November 21, 2016
BOARD OF COUNTY COMMISSIONERS
ORANGE COUNTY, FLORIDA
Addendum No. 2, IFB Y17-713-CC
BARNETT PARK AIR HANDLING UNITS REPLACEMENT

1. Revision: The following attached drawings have been revised:

Project:
Barnett Park AHU Replacement

SECOND FLOOR PLAN - HVAC.
SCALE 1/8" = 1'-0"

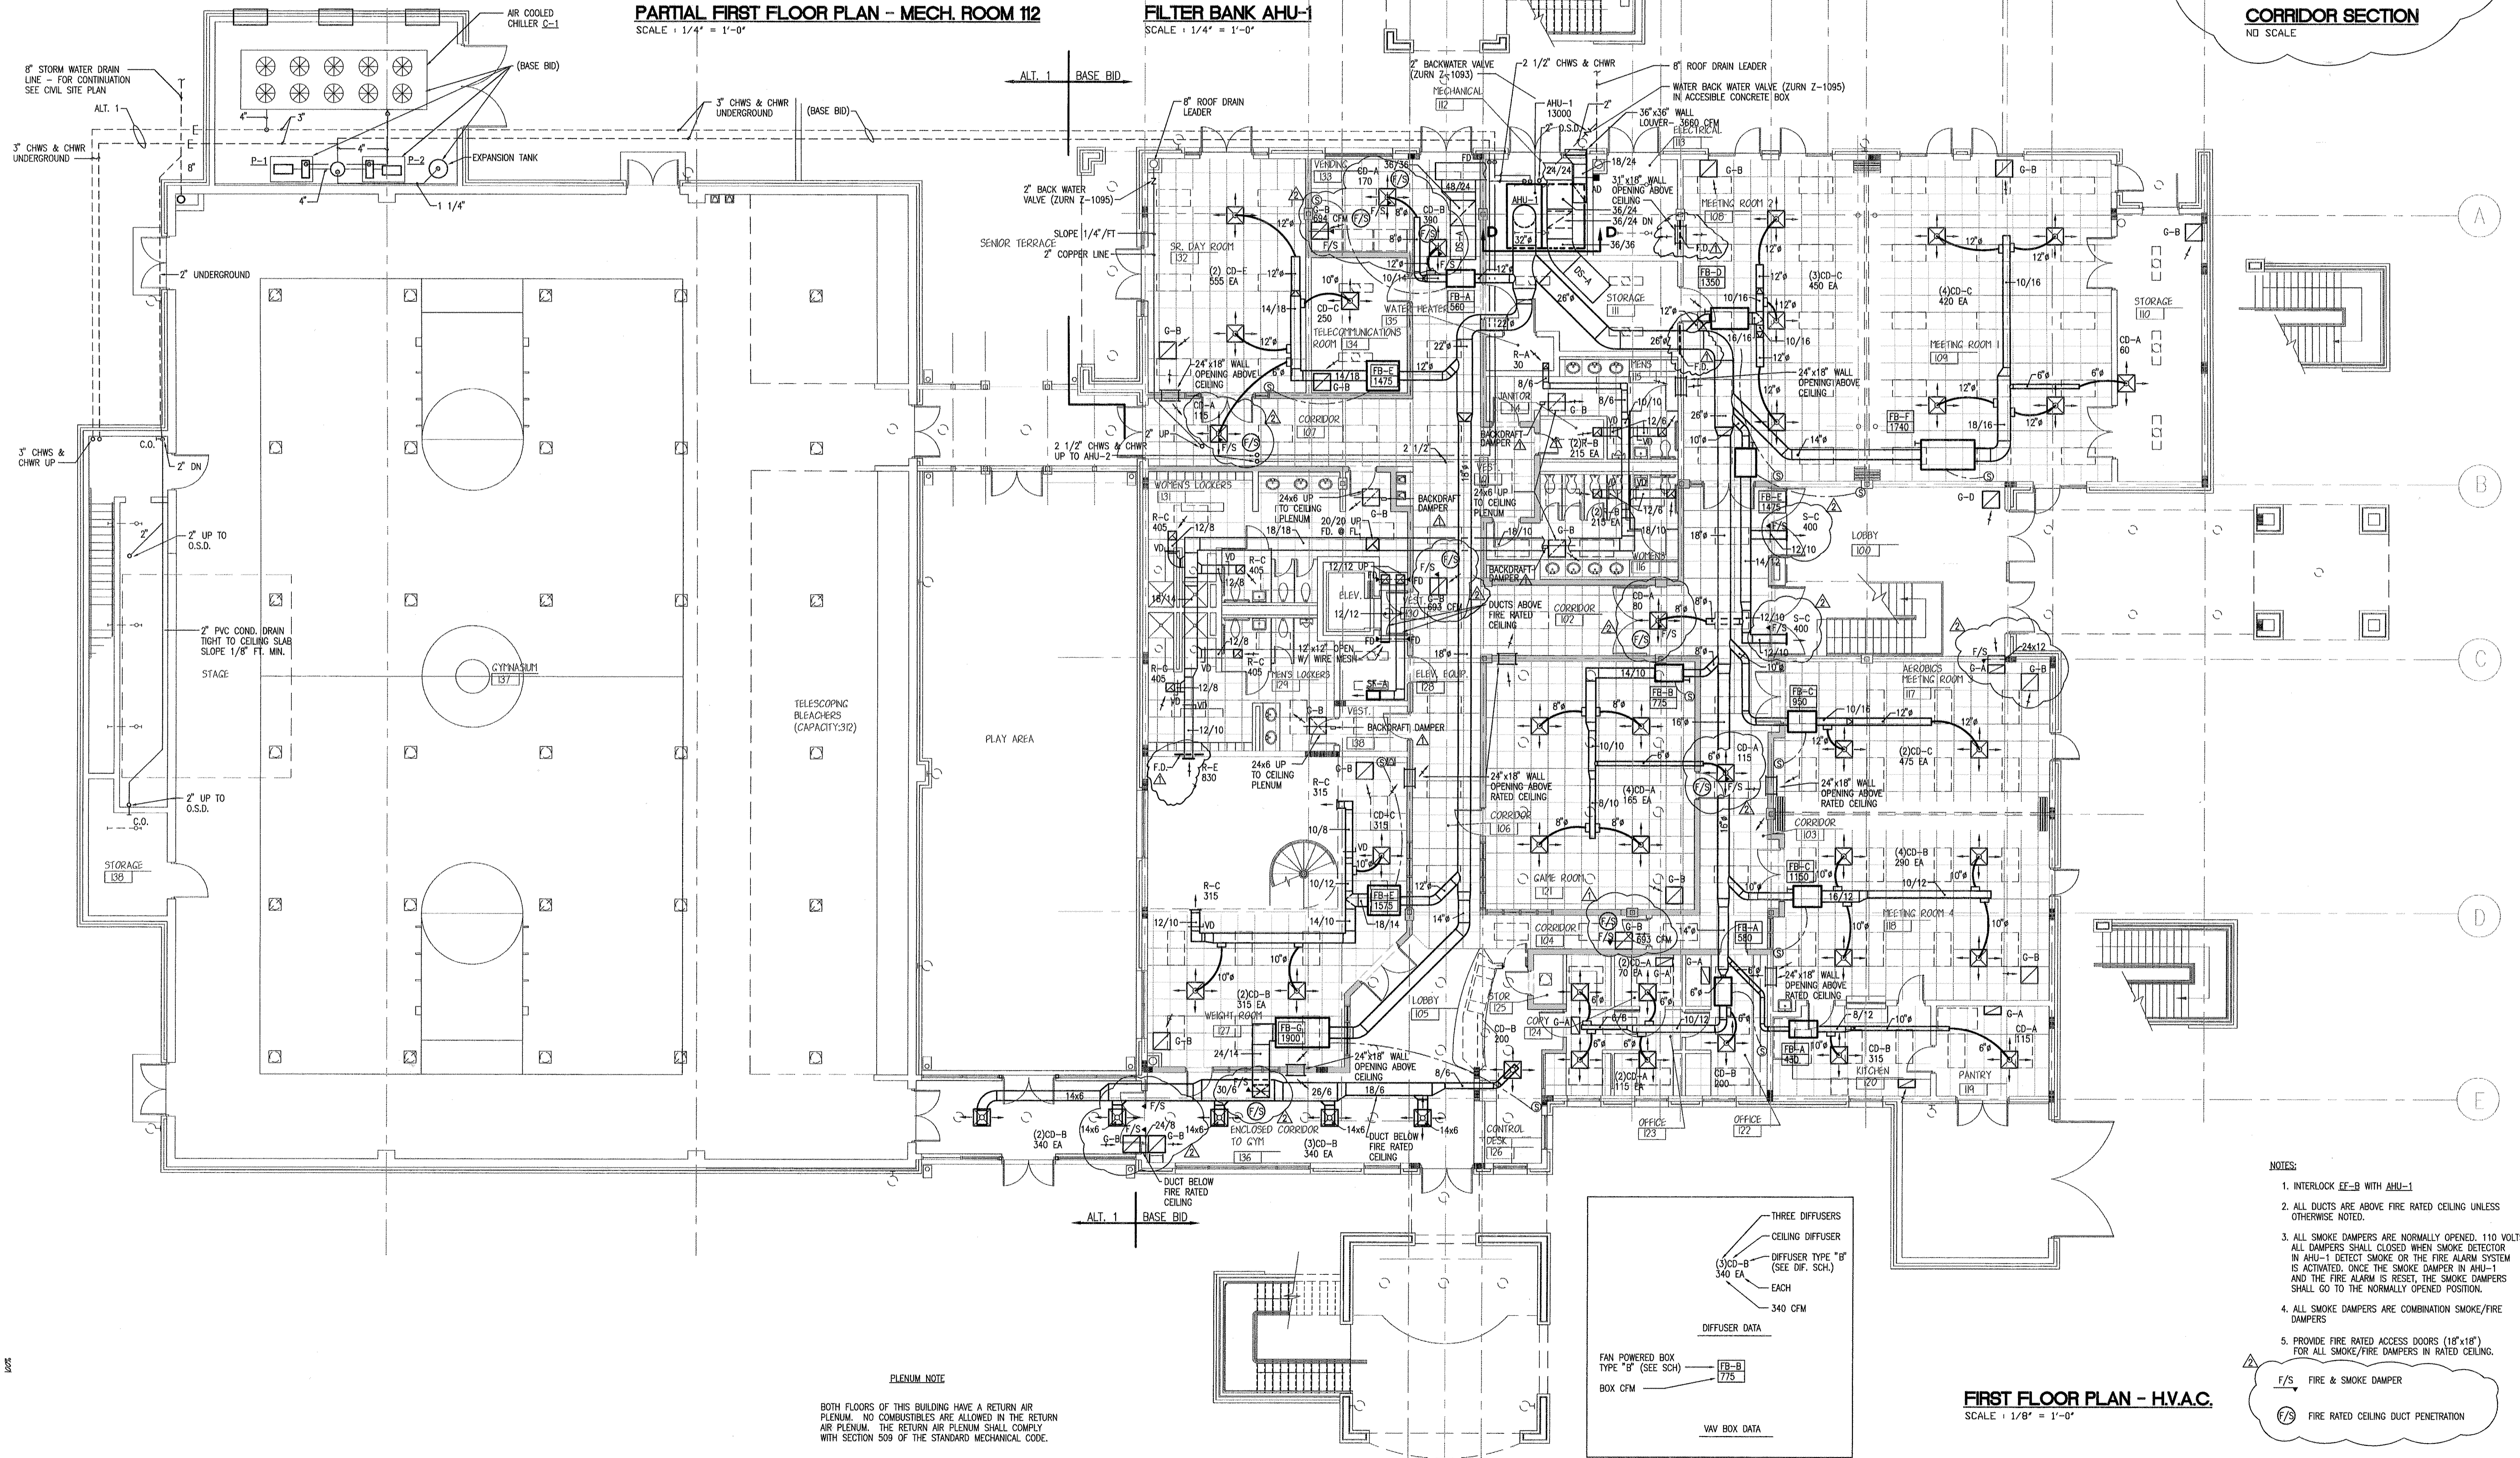
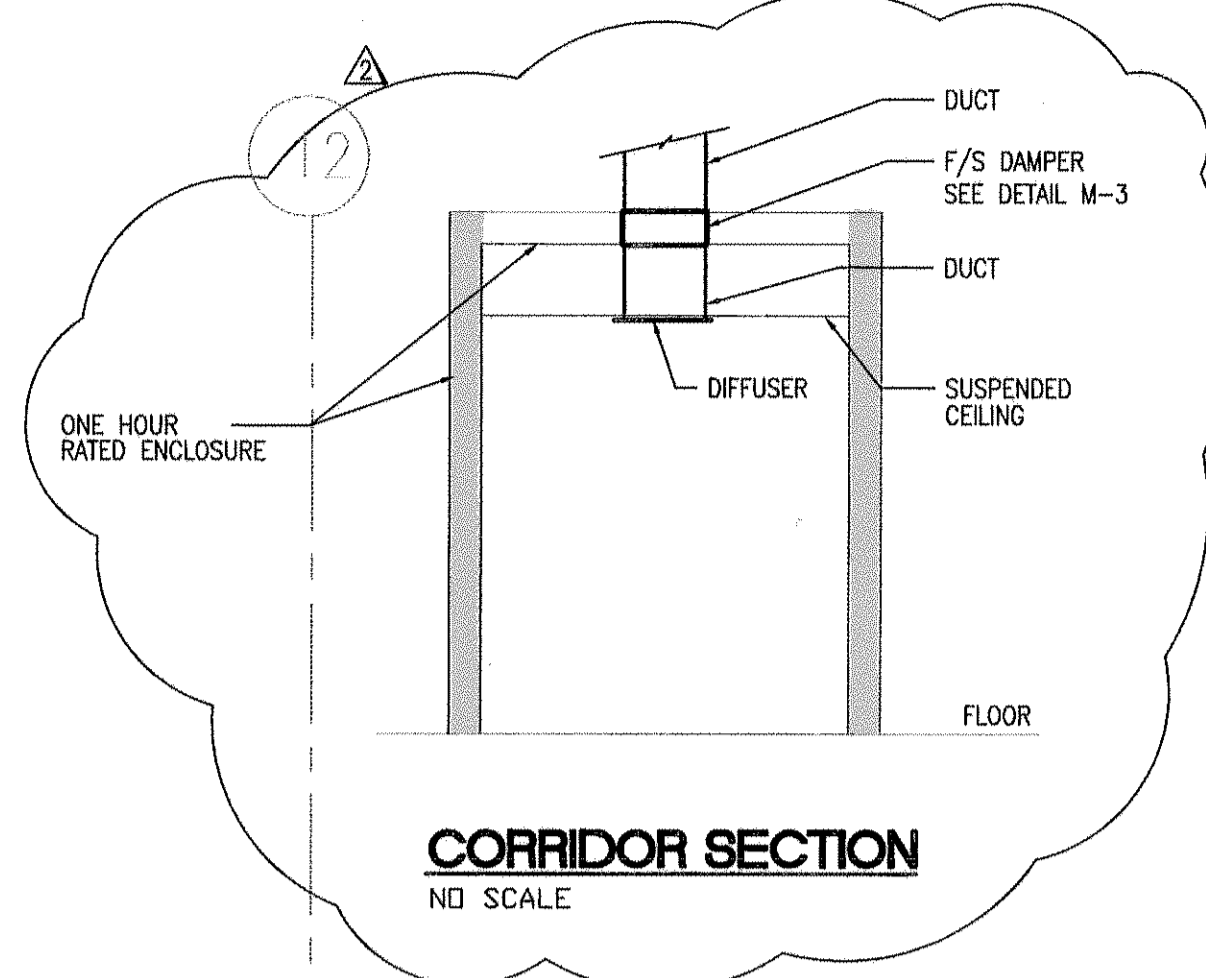
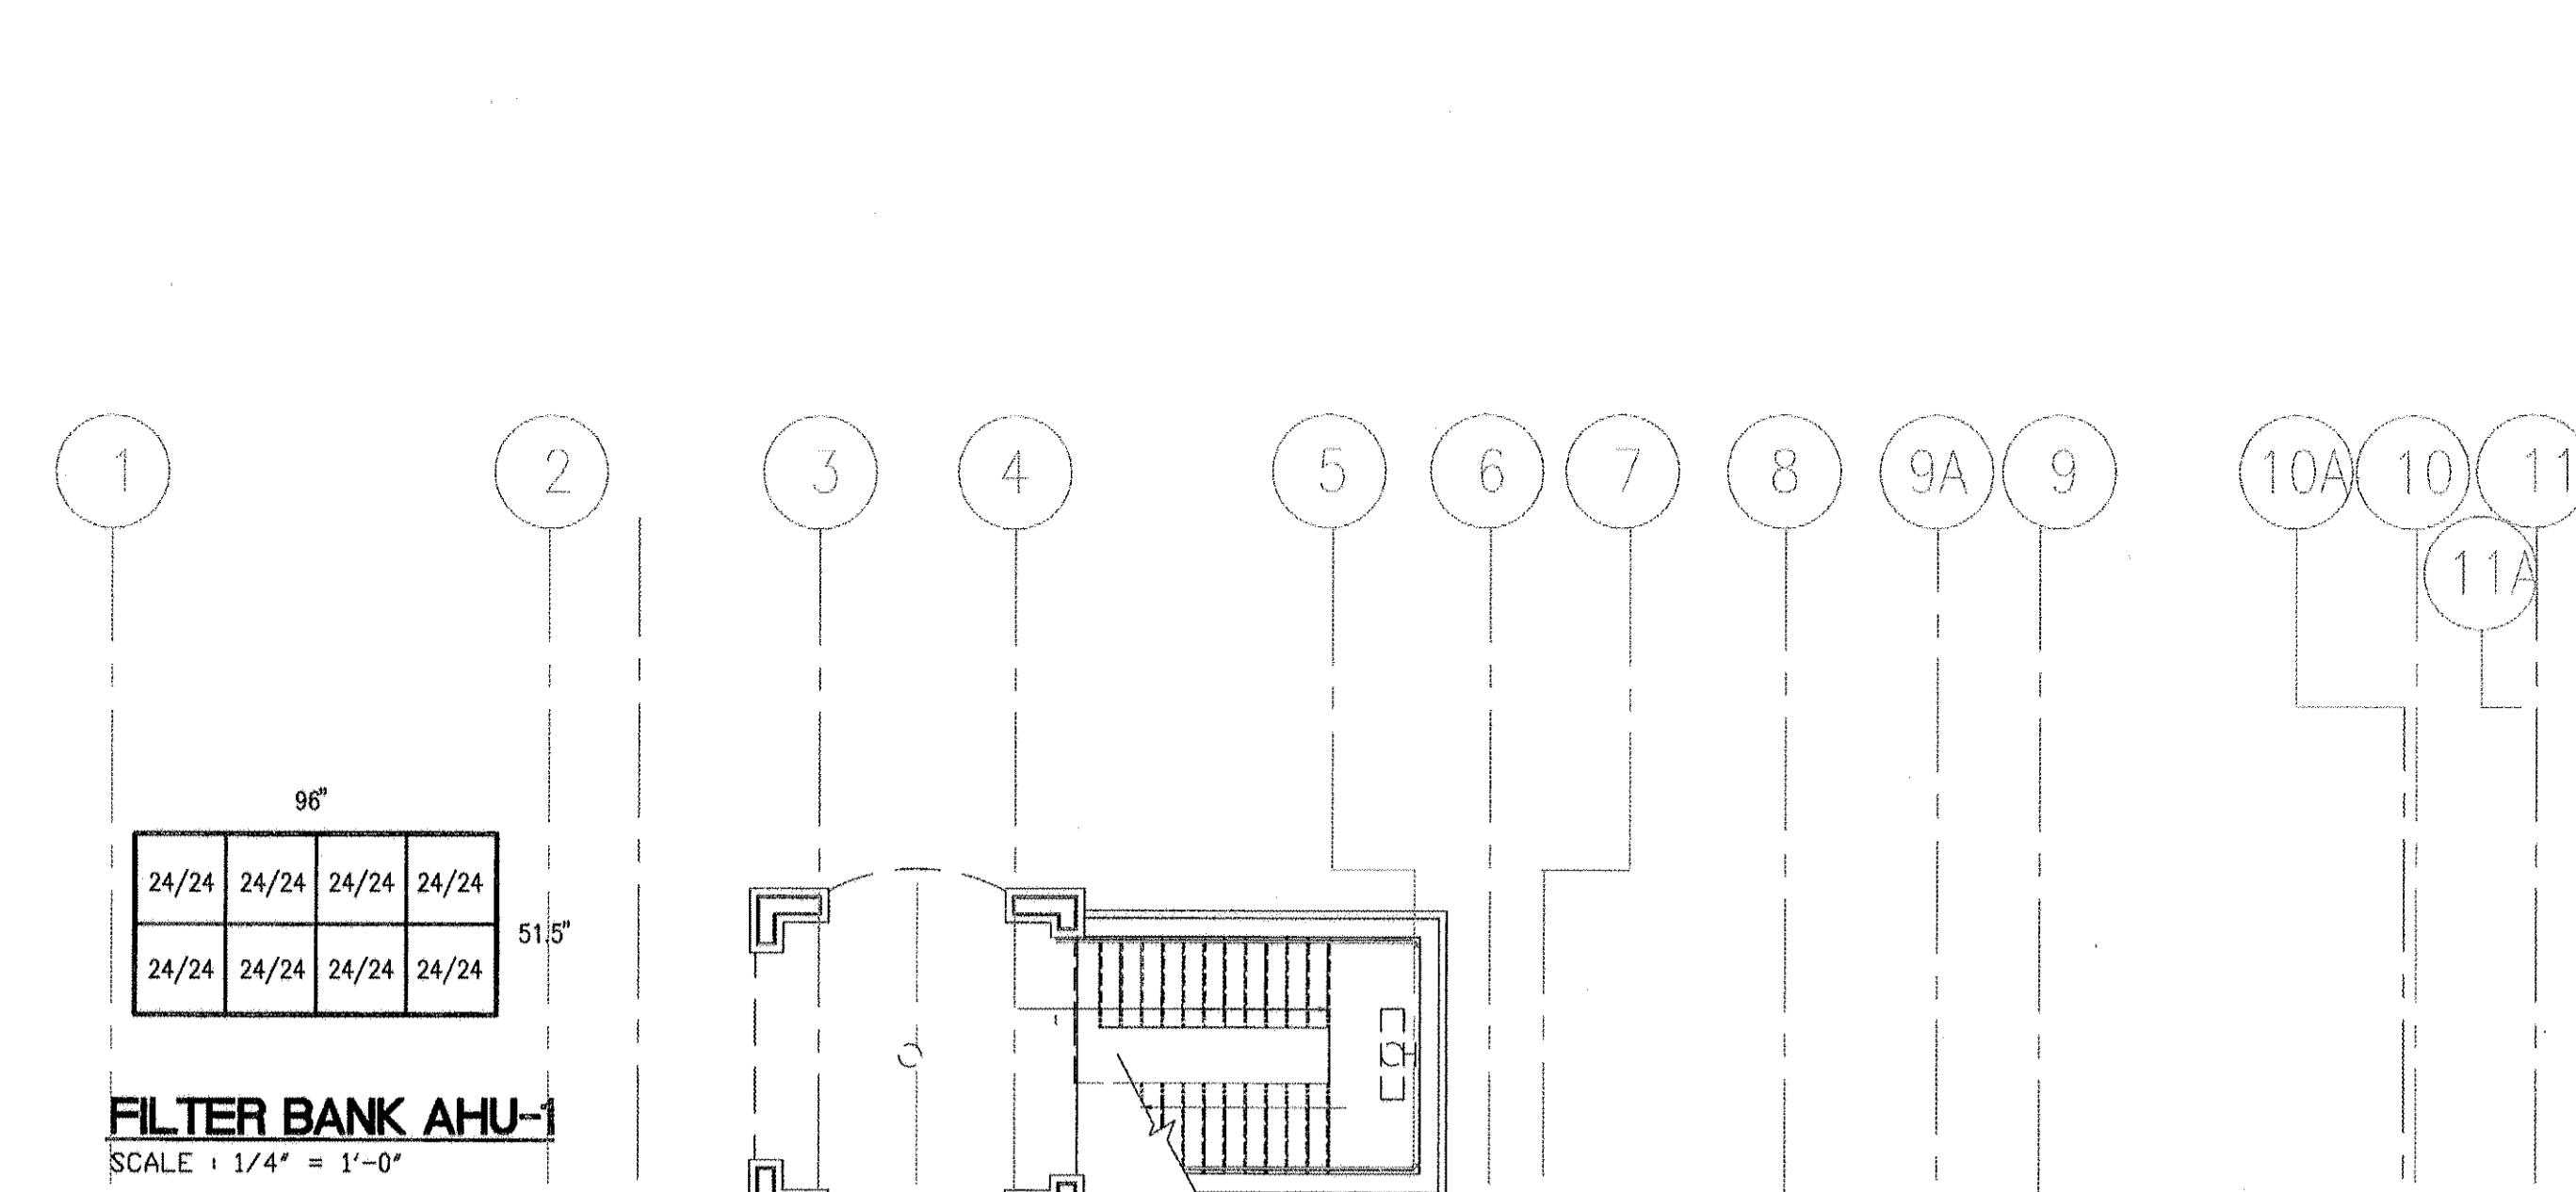
13. Question: Can you provide Architectural Reflected Ceiling as-built drawings for the first and second floor areas indicating replacement of ductwork as shown on M103? Mechanical Drawings do indicate a specific area of a fire-rated ceiling.

Answer: Please see the attached as-built drawings provided for information only (Sheet M-1 dated 5/25/1995, and Sheet M-2 dated 5/25/1995). In addition, per Orange County Facilities Management, these areas are acoustical ceiling tile. Refer to Sheet M403 for fire rated lid construction and location.
